TYPE NO H&C	TYPE FB55 - 7100 - CV7200/7300 – 7300 - 7600	T.I. NO 05 - 2014				
SERIAL NUMBERS AFFECTED	From and including S/N (see table included)	ISSUED BY Documentation/N&W Valbrembo				
SUBJECT NEW POSTER DEMB NETHERLANDS		ISSUED FOR (X): <table border="1"> <tr> <td>Action</td> <td></td> </tr> <tr> <td>Information</td> <td>X</td> </tr> </table>	Action		Information	X
Action						
Information	X

Due to a new aesthetical request for the Netherlands market, a new Poster has been introduced. Below a picture of the old “Poster Frame Assembly”: Poster Frame + a **Sandwich** made by

Poster Frame –New situation ONLY
for The Netherlands

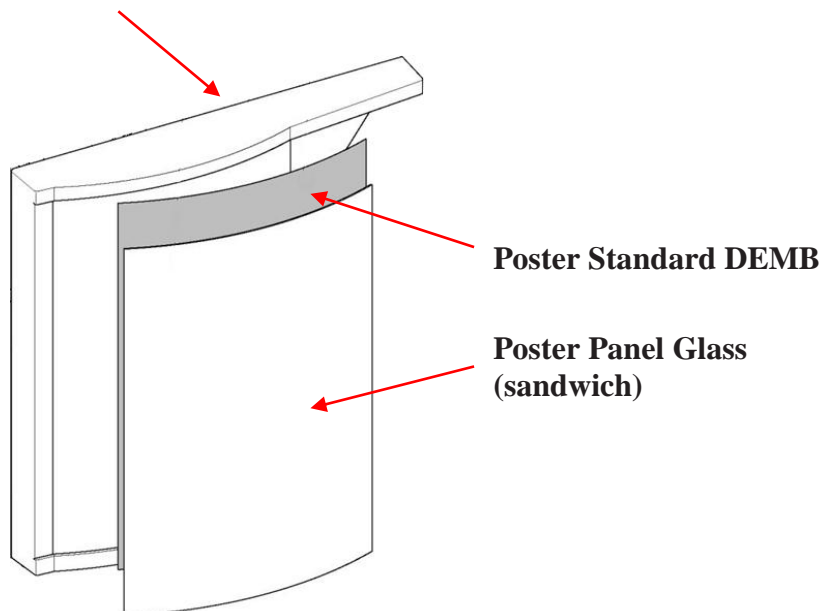
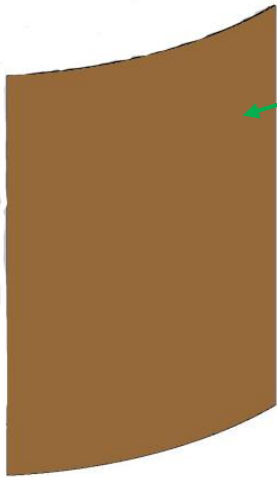
The new Poster “**Black background and beans DEMB**” is no longer a sandwich made of two pieces, but it’s a single graphic panel directly mounted in the door of the machines above mentioned.

The poster material (PVC treated) is different from the previous one due to the direct contact with the final user in front of the machine.

The new Poster can be installed in all the Gallery Coffee Vending machines prior to the above mentioned serial number: have to be removed the old poster and the poster panel glass related (plus the poster opaline where installed – ES PREMIO) and installed directly in the machine front door.

Gallery 420

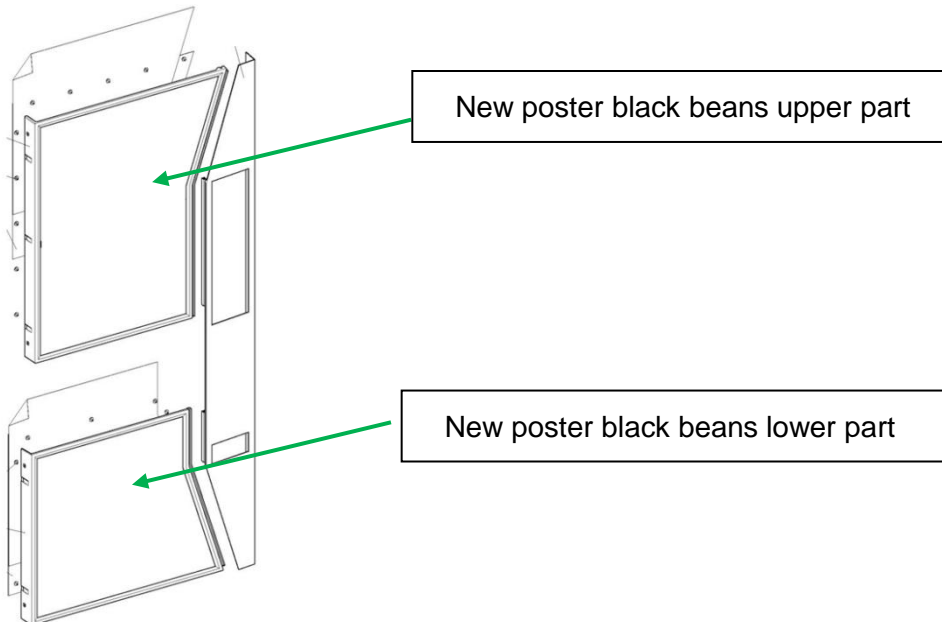
For machine as Gallery 110 and Gallery 420 the poster material is the same, has changed only the layout for the Dutch machine (see below in the table the details in term of codes and version).
